RECEIPT DATE: 5/10/18 **ONSITE SEWAGE DISPOSAL SYSTEM**

PROPERTY ADDRESS: 1030 Fairlane Road

SUBDIVISION: Fairlane Farms

**SEPTIC SYSTEM  
 INSTALLATION SITE PLAN  
 LOT 24  
 1030 FAIRLANE ROAD  
 FAIRLANE FARMS**

SCALE: 1"=50'  
DATE: 5/8/18  
DRAWN BY: MD  
CHECKED BY: MLR  
PROJECT No.: 05106-3003

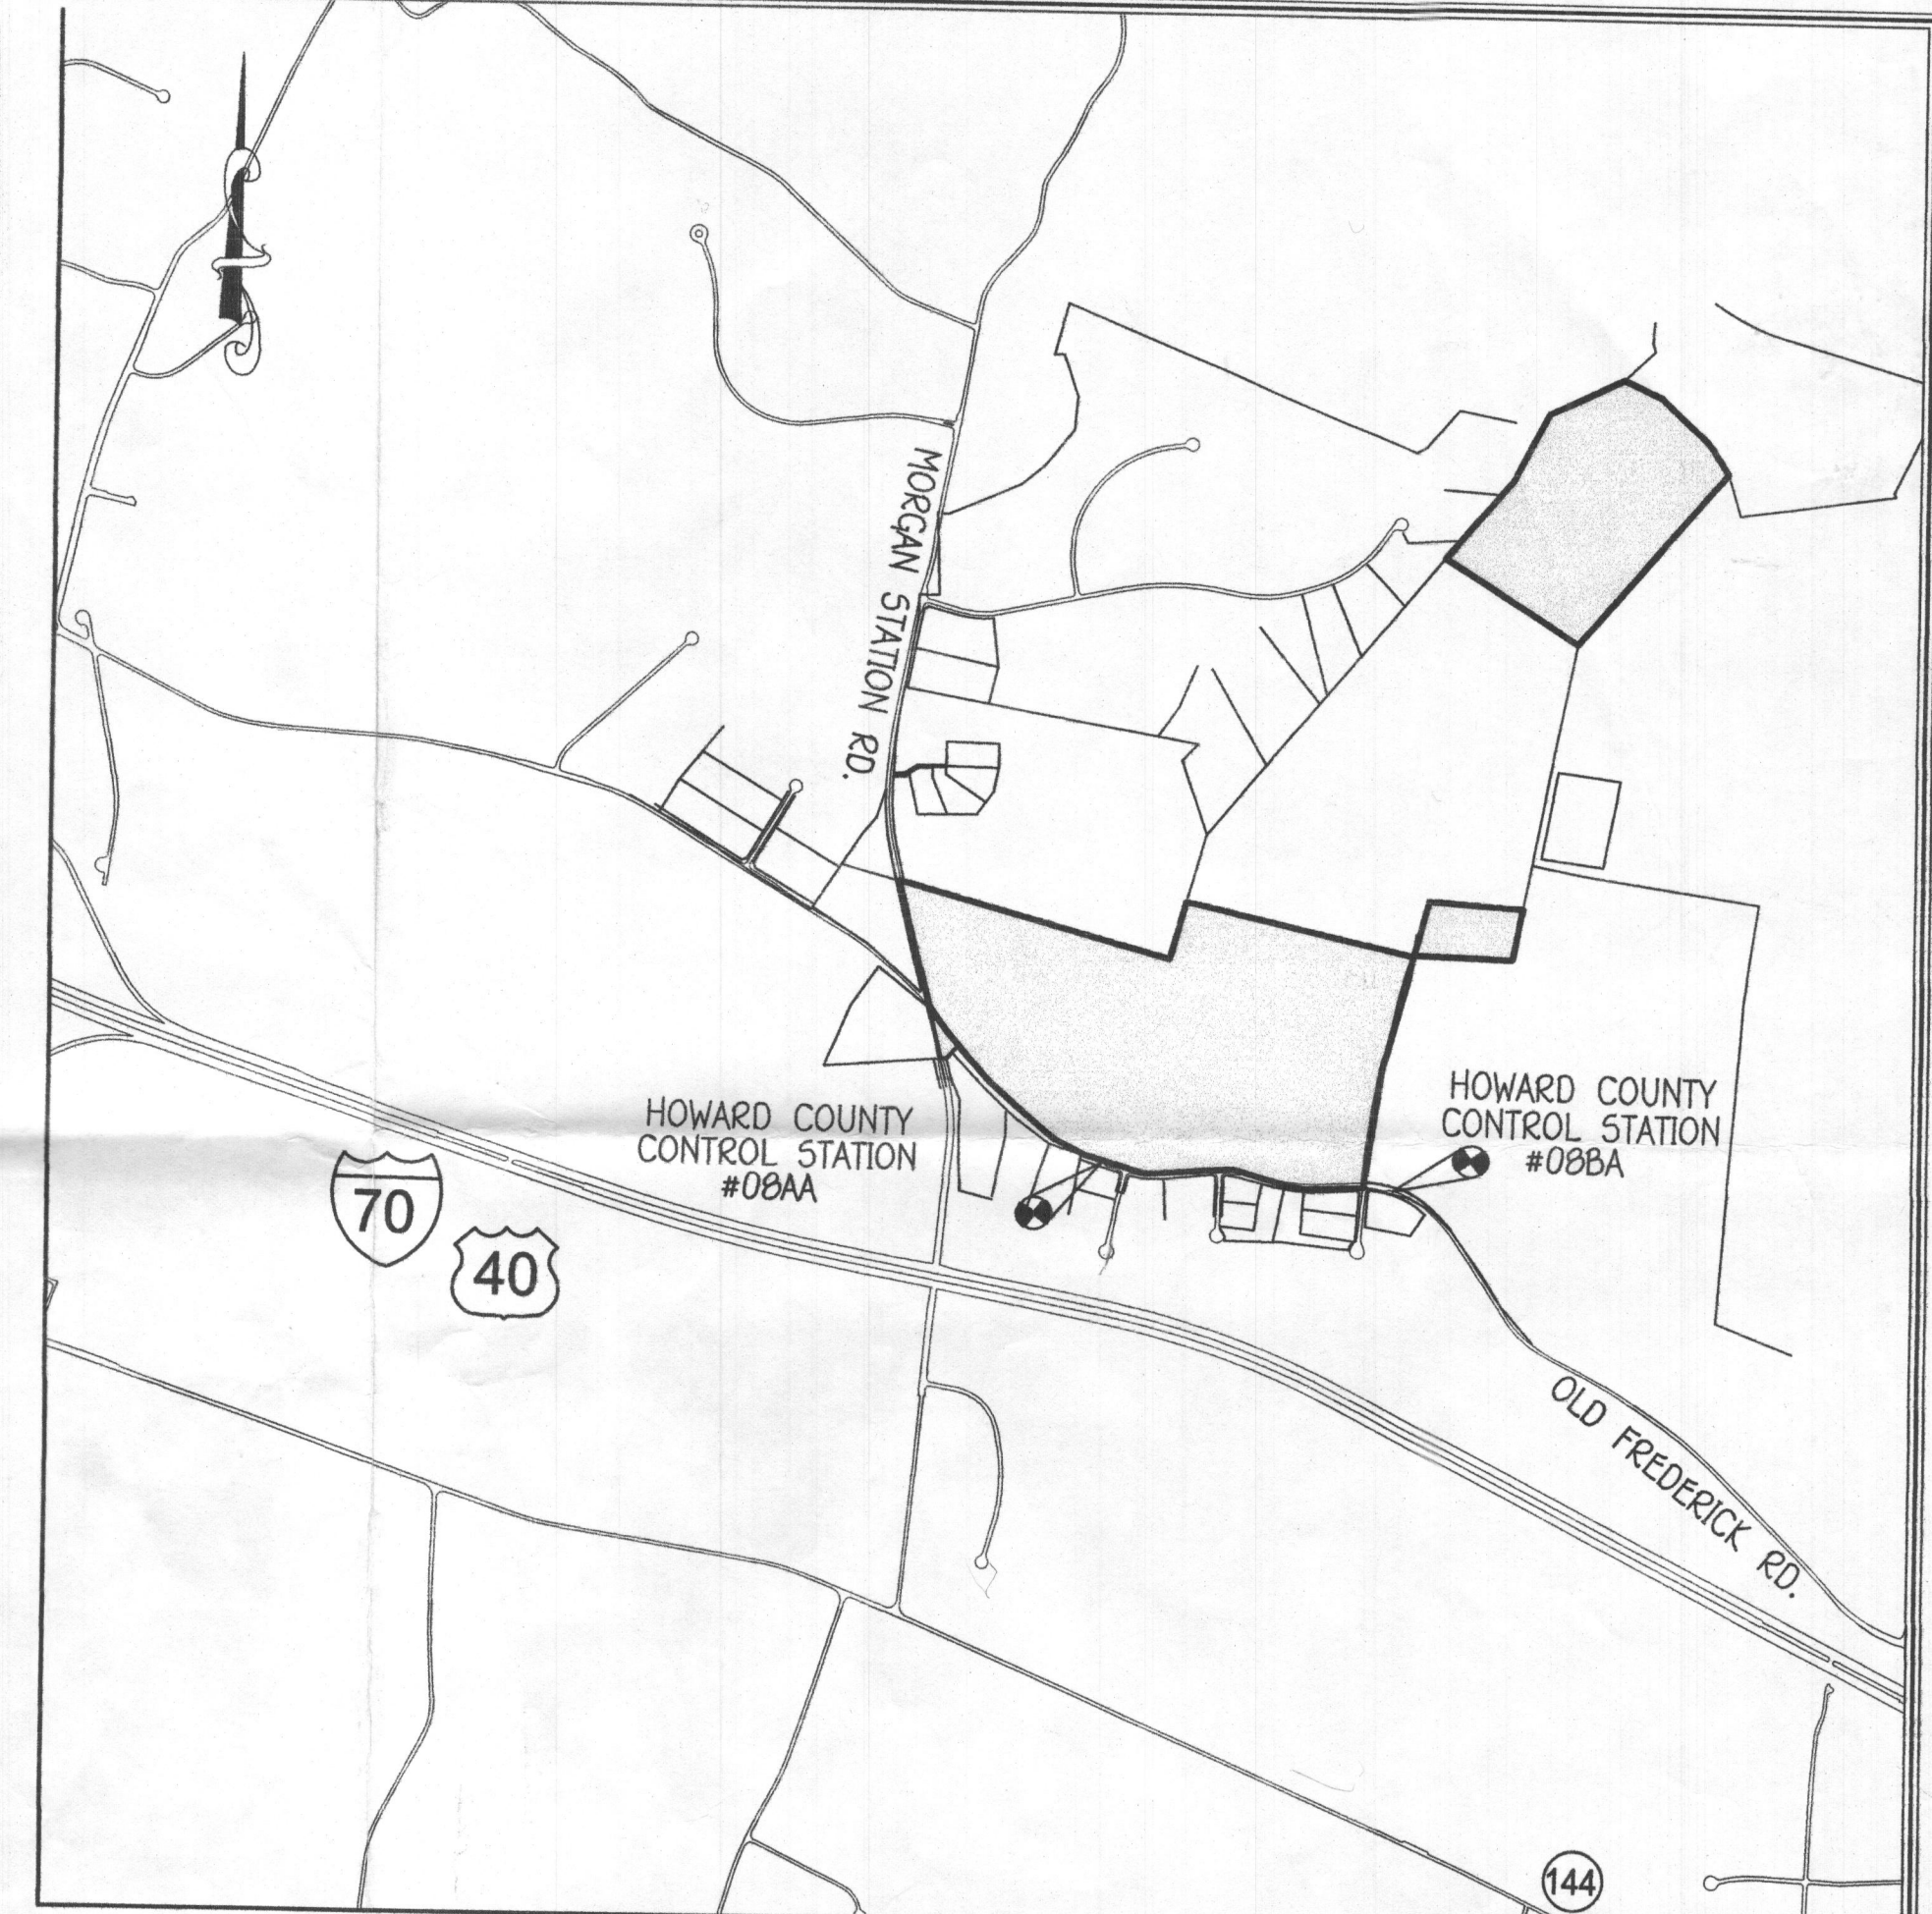
The OSDS Plan for Lot 24 does not match Kevin's specs. You are showing 4 trenches @ 39 ft. and using 3 foot of sidewall. Please revise to match or call to discuss.

We would like to see the d-box brought up to the 598 contour and we still want the trenches split due to the contour.

- 1.) Utilize the area at the top of the SDA by placing the d-box further up and start the trenches in the center (See attachment for layout recommendation).
- 2.) Re-exam invert elevation out of the house to ensure that it won't interfere the house foundation.
- 3.) Show additional step in calculation (i.e.  $937.5/3 = 312.5$ ).

- 1.) Match basement elevation 596.80 to 596.60 or vice versa
- 2.) Match well tag # on plan with note.
- 3.) Match invert elevations out of the house for the "Septic Profile" (594.97 or 592.05?)
- 4.) Match invert elevations in profile with invert elevations listed next to trench data.
- 5.) Raise trench invert up to 2 feet in order to utilize the 3 foot reduction credit by showing this in the "Initial Trench Detail". Adjust elevations accordingly.
- 6.) Make bottom depth 5 feet (not 7 feet) for "Initial Trench Detail"
- 7.) Entire well box must meet 10 foot setback to driveway.

**INITIAL SYSTEM**  
 SEWAGE DISPOSAL SYSTEM DATA DESIGN FOR 5 BEDROOMS  
 LOADING RATE = 5 BEDROOMS X 150 GPD/BEDROOM = 750 GPD  
 APPLICATION RATE = 1.2  
 EFFECTIVE SIDEWALL BEGINS AT 4 FEET  
 TRENCH DEPTH = 6 FEET  
 TRENCH WIDTH (W) = 3 FEET  
 EFFECTIVE DEPTH (D) = 2 FEET  
 SF OF DRAINFIELD = 750 GPD / 1.2 = 625 SF  
 COEFFICIENT OF REDUCTION OF TRENCH LENGTH = (W+2)/(W+1+2D) = (3+2)/(3+1+(2x2)) = .62  
 TRENCH LENGTH = 208 SF x .62 = 129 FEET  
 (USE 3 TRENCHES AT 43 LF.)  
 TRENCH SPACING = 2D+W = ((2x2) + 3) = 7' USE 10'
